**BEFORE
THE OHIO POWER SITING BOARD**

In the Matter of the Application of	)	
Kingwood Solar I LLC for a Certificate	)	Case No. 21-0117-EL-BGN
of Environmental Compatibility and	)	
Public Need	)

**NOTICE OF RESPONSES TO DATA REQUESTS FROM
THE STAFF OF THE OHIO POWER SITING BOARD**

**KINGWOOD SOLAR'S OCTOBER 12, 2021 RESPONSES
TO STAFF'S SEPTEMBER 29, 2021 DATA REQUESTS**

**Figure 03-3
Project Layout**

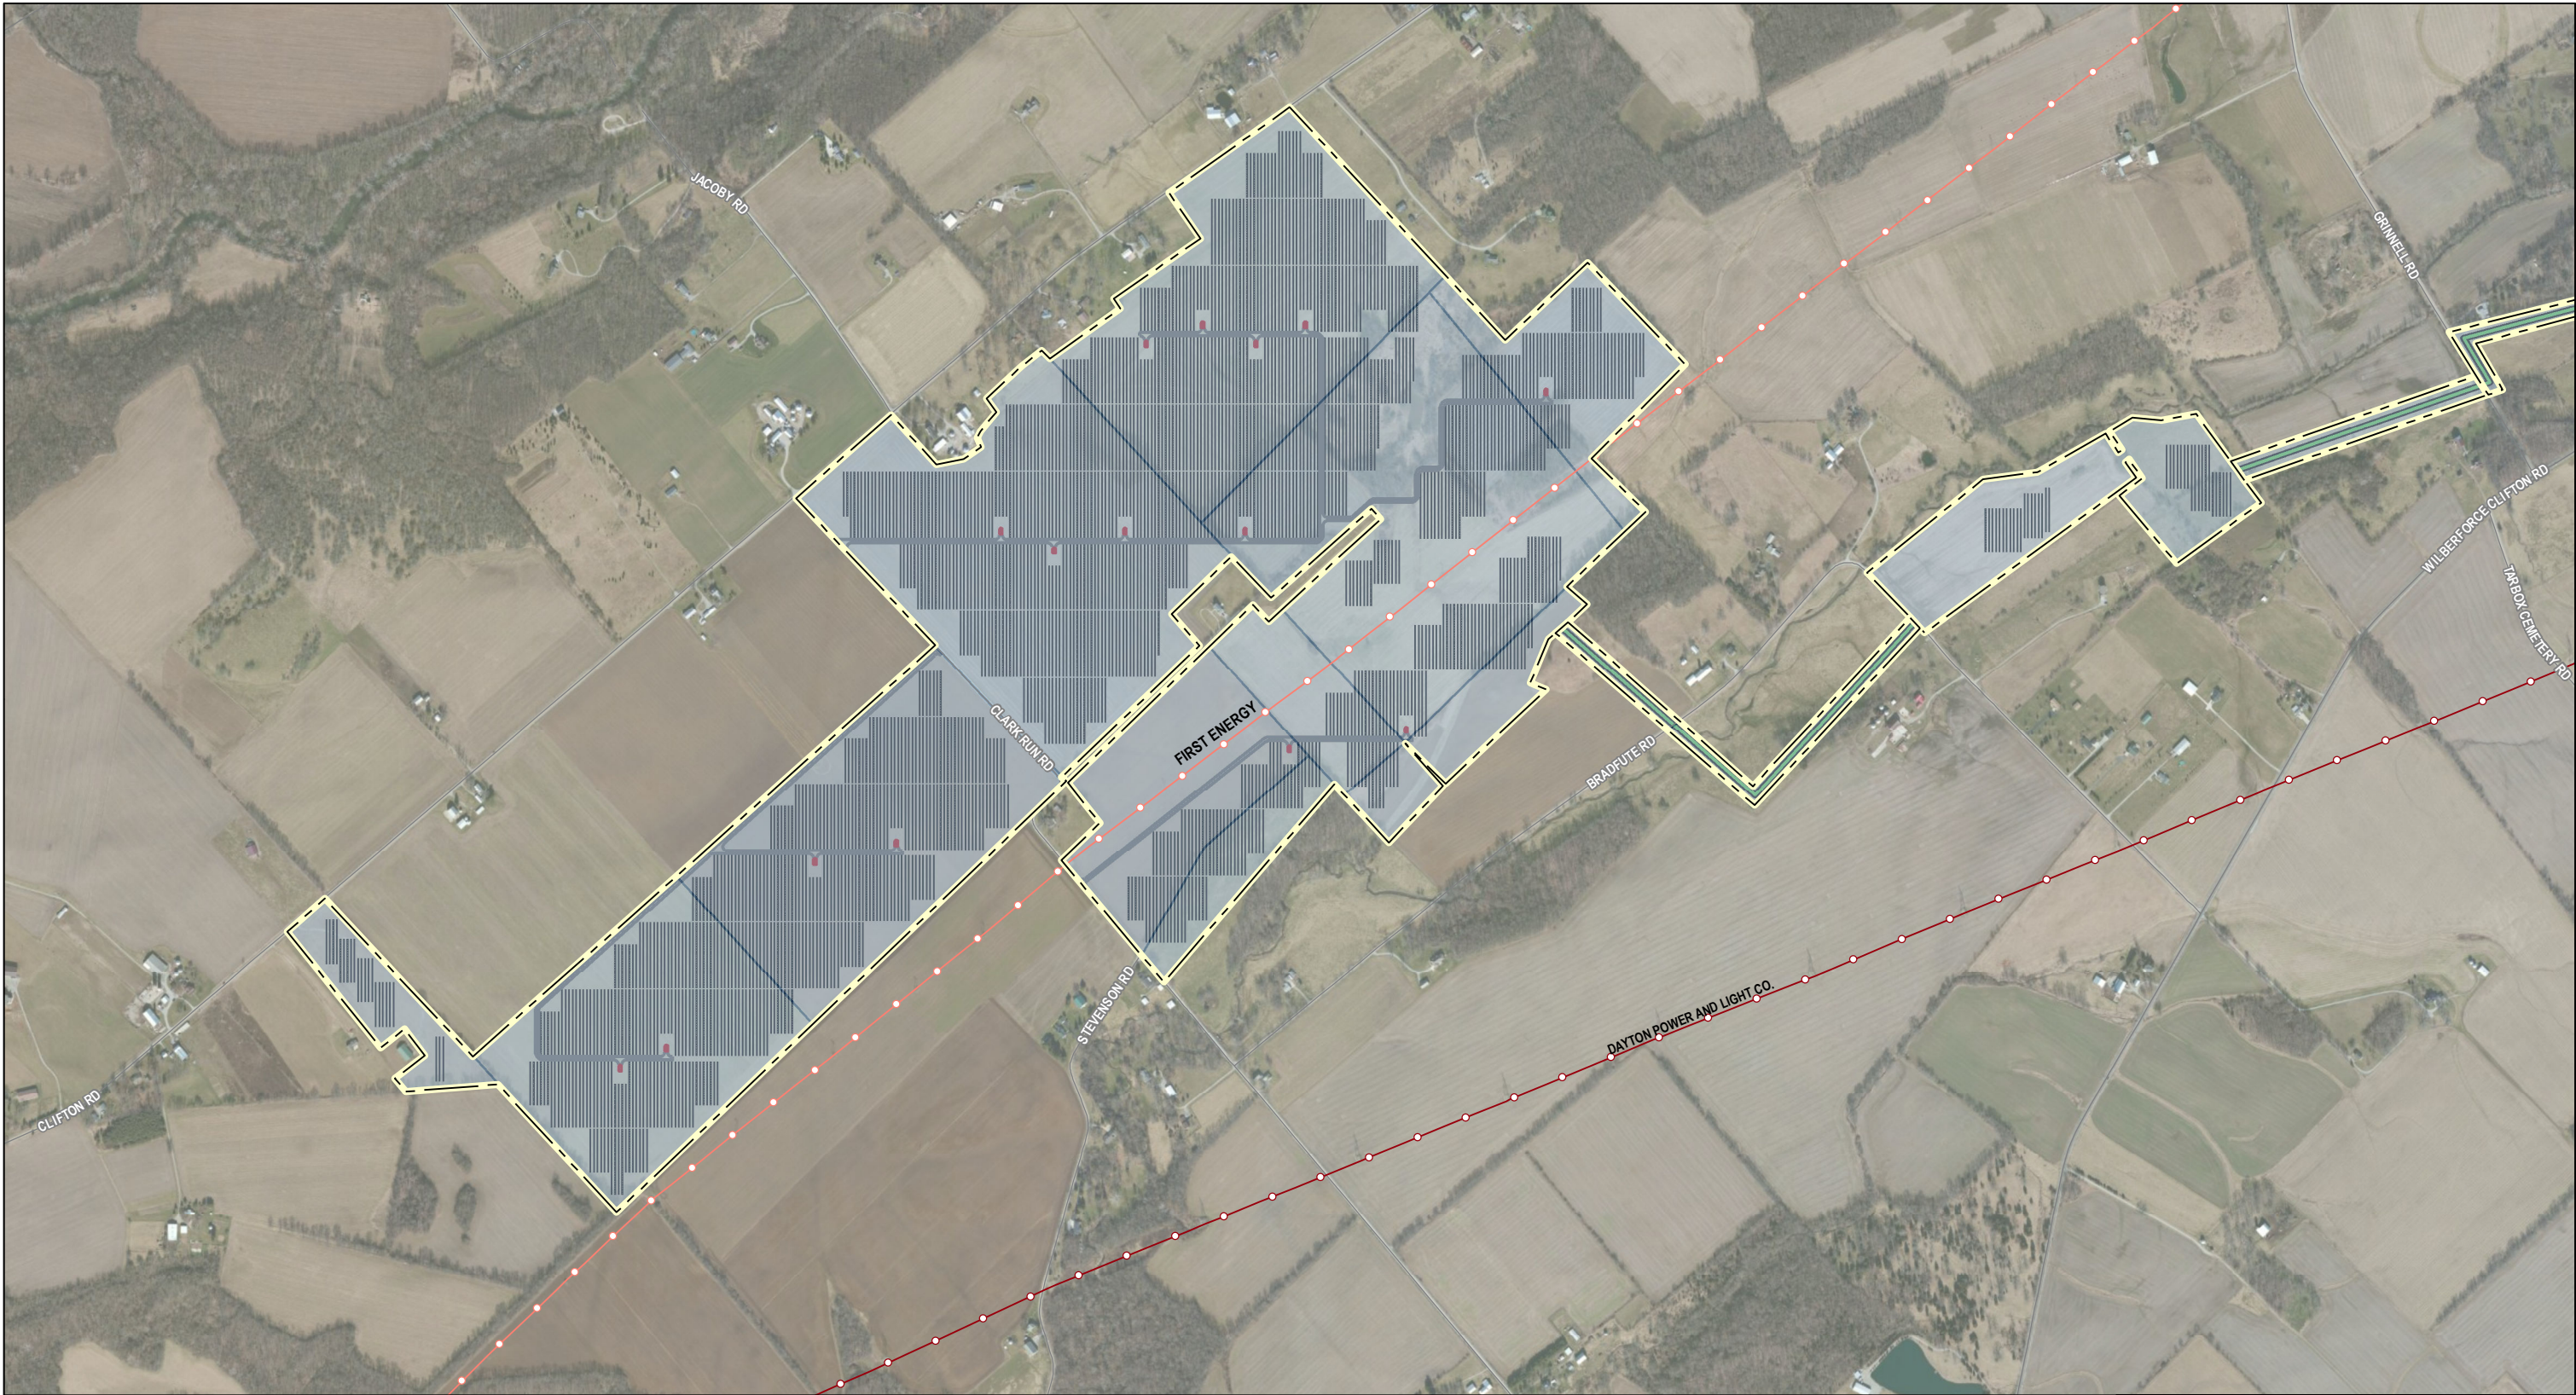
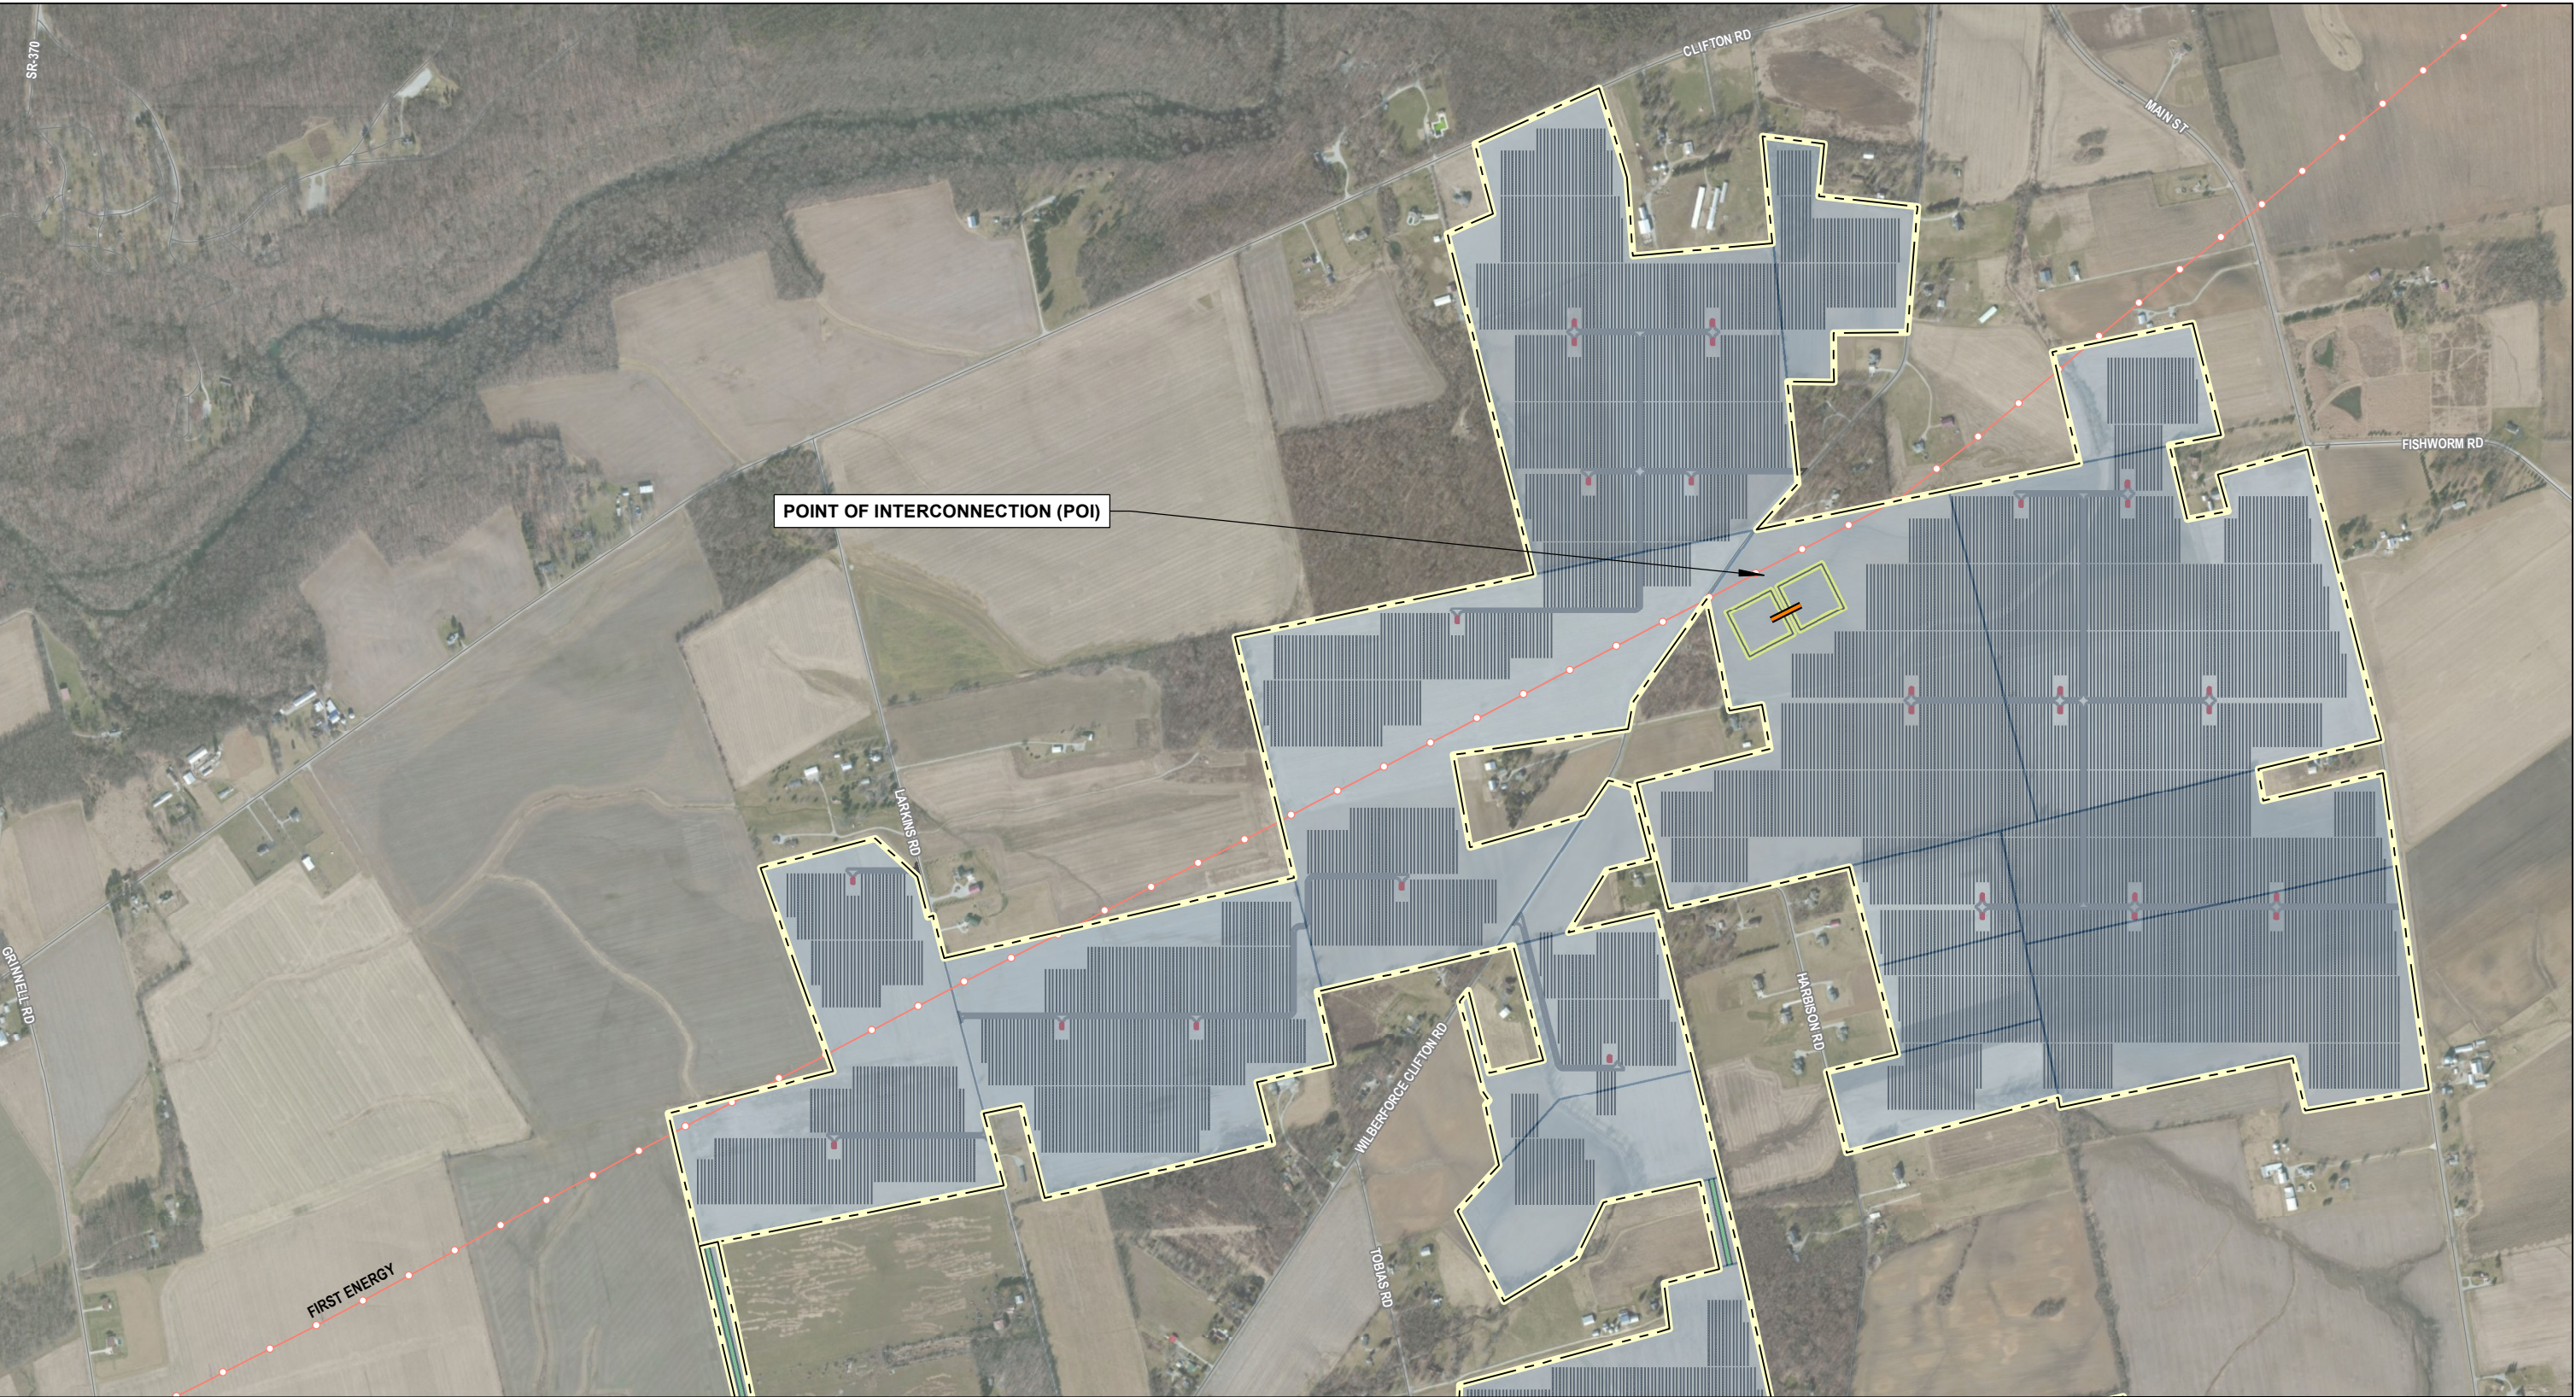
15. In follow up to Kingwood Solar's June 1, 2021 Responses to Staff's May 17 and May 20 Data Requests (DR#20) which included an updated Figure 03-3, the included Figure 03-3 doesn't depict the 200 feet of 138 kV gen-tie line but only a POI. Please provide an updated Figure 03-3 (Project Layout) and other relevant facility mapping that depicts the specific proposed location of the gen-tie line referenced on page 1 of the Application and provide associated shapefiles.

An updated version of Figure 03-3 is provided depicting the approximate location of the 200-foot 138-kV gen-tie mentioned on page 1 of the Application. This location may shift slightly depending on the final design of the interconnection facilities.
